ITEM FOR ENVIRONMENTAL COMMISSION AGENDA

NAME & NUMBER OF PROJECT: SP-2019-0108D Thaxton Road Tract Offsite Wastewater Improvements

REQUEST: Variance request is as follows:
Request to vary from LDC 25-8-261 to allow development within a Critical Water Quality Zone

STAFF RECOMMENDATION: Staff does not recommend this variance, having determined that the findings of fact have not been met.

THAXTON ROAD
OFFSITE WASTEWATER LINE
6810 COLTON BLUFF SPRINGS RD
WASTEWATER LINE 'A' (19+00 - 28+00)

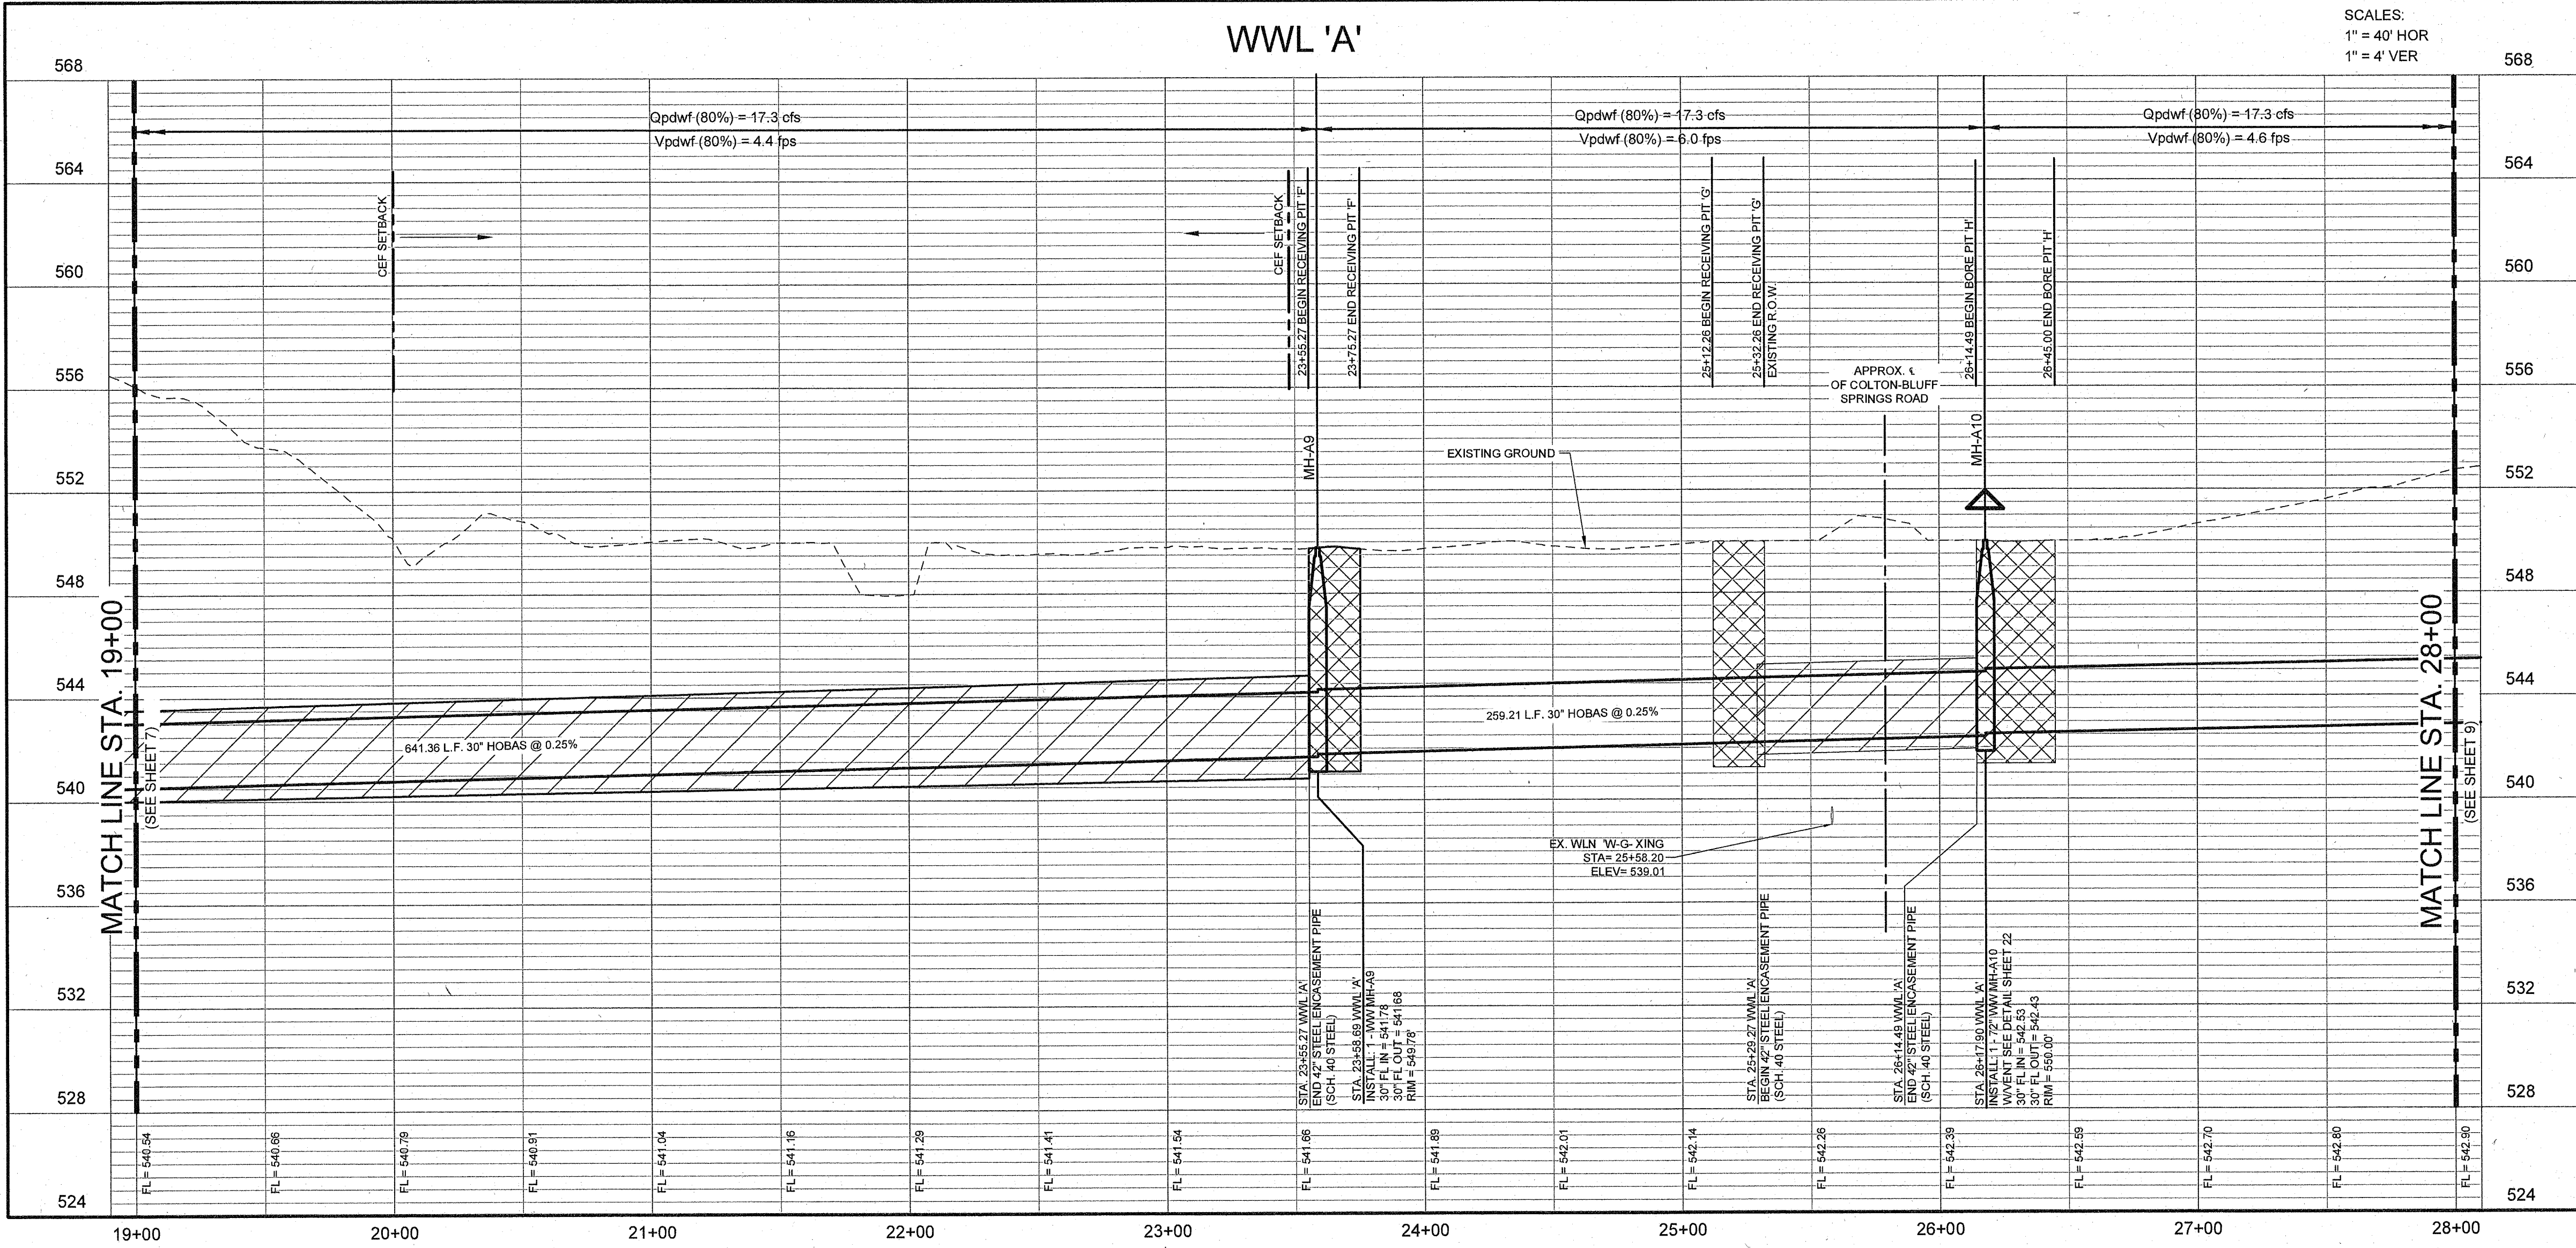
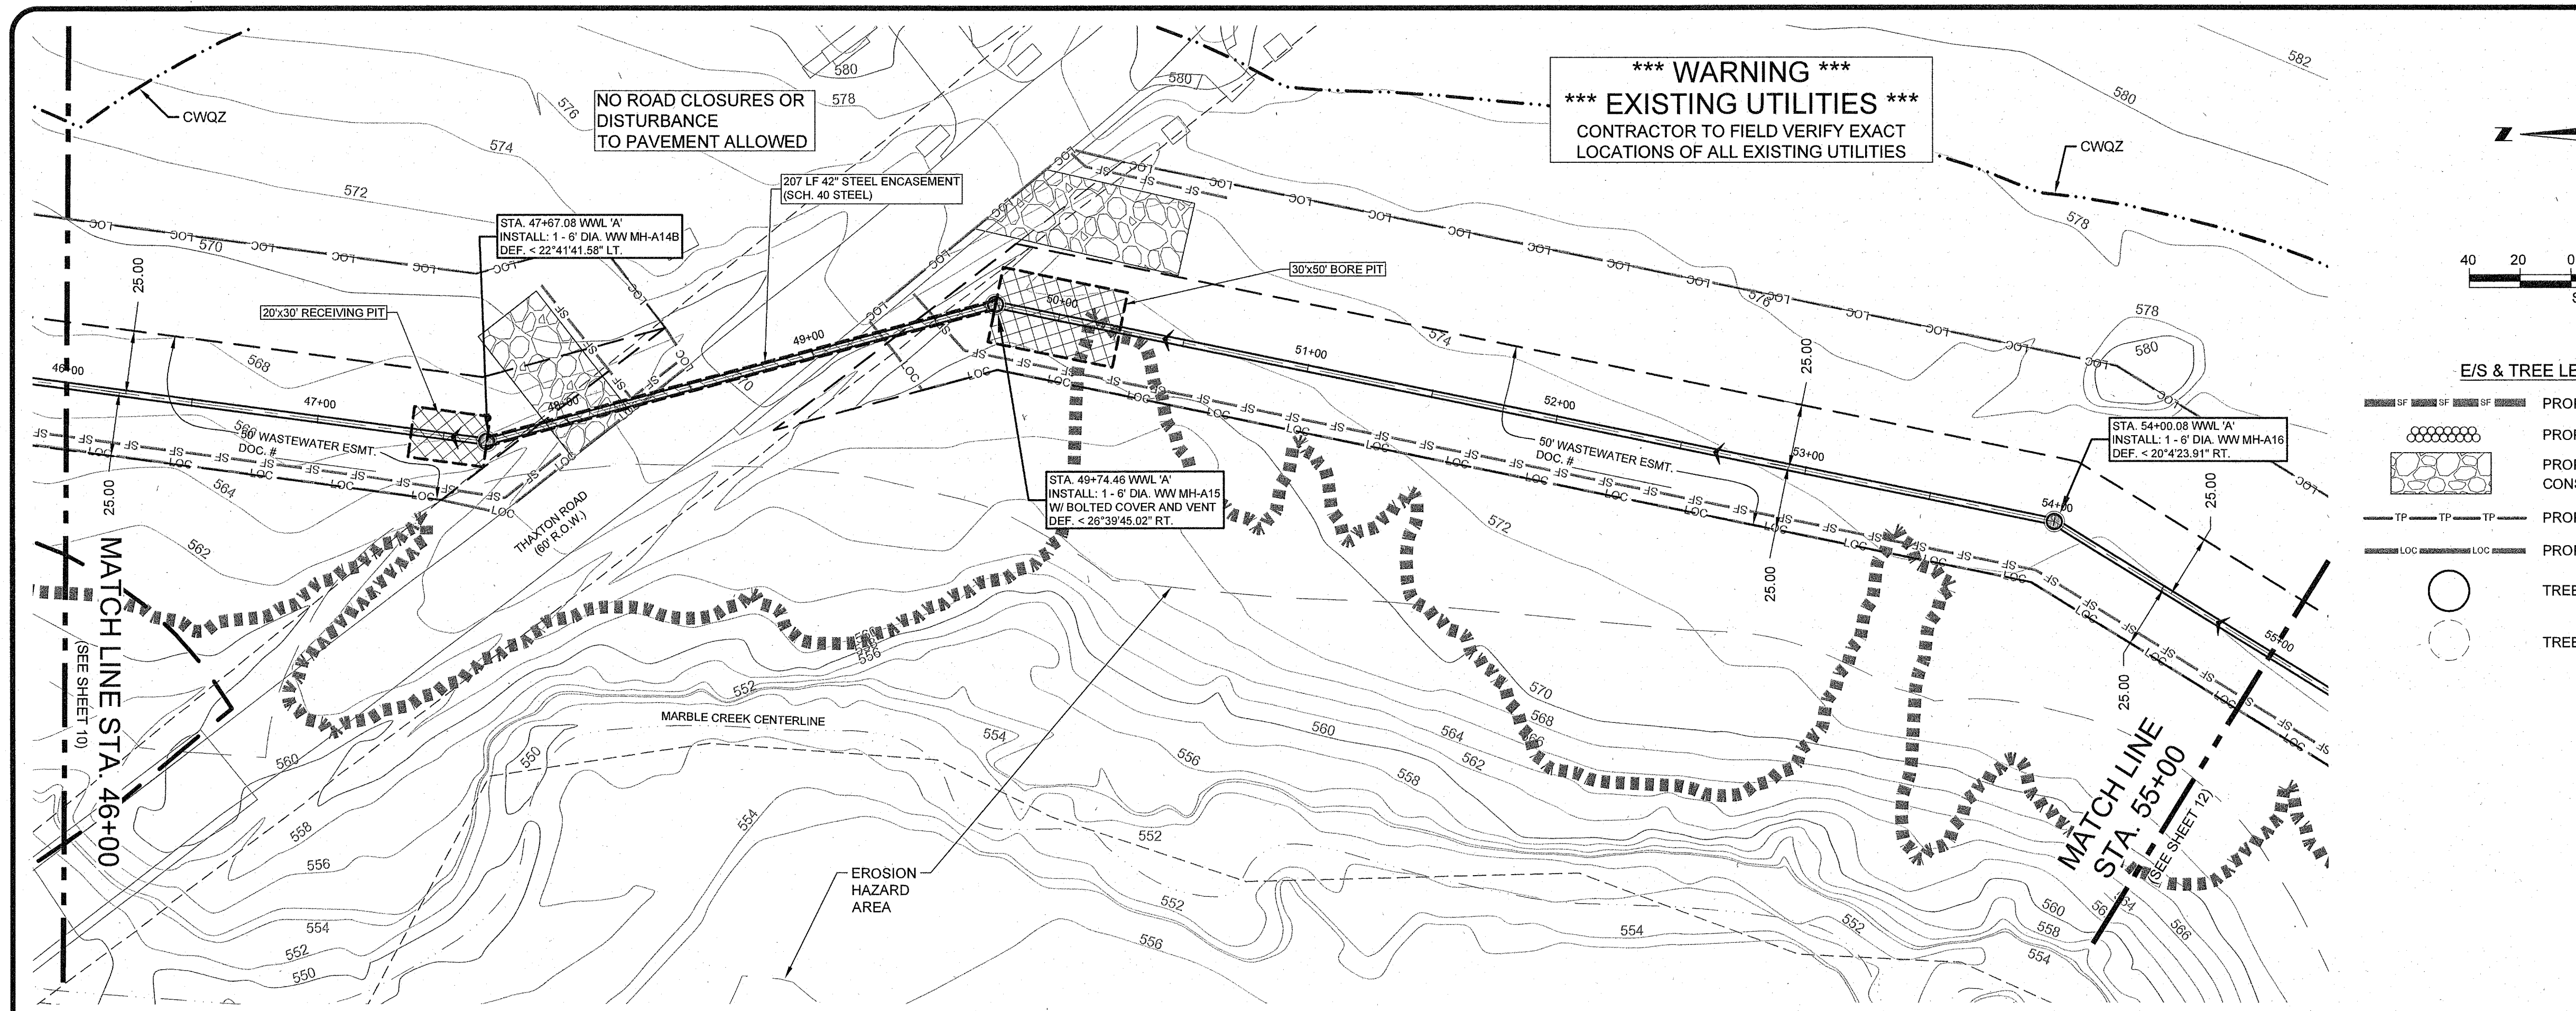
No. Alternative alignments that would not encroach into the minimum setback of the critical water quality zone exist. However, the applicant intends to take advantage of an already dedicated easement and provide a gravity-fed wastewater line, rather than dedicate a new easement within the right-of-way and provide a force main line with lift stations, as needed. As proposed, the wastewater line will result in permanent alteration of the critical water

quality zone and does not provide greater overall environmental protection because of the potential for leaks and breaks in the line resulting in sewage overflows into clean-flowing creeks.

No. As currently designed, the proposed wastewater line construction intends to bore under the critical water quality zone and the erosion hazard zone, with an overall approximate average depth of 8-12 feet, resulting in disturbance to subsurface hydrology and removal of native soils. The proposed wastewater line will require future repairs from eventual breaks and sewage overflows, which will require trenching to repair the line that equates to removal of riparian vegetation and disturbance to hydrologic functions.
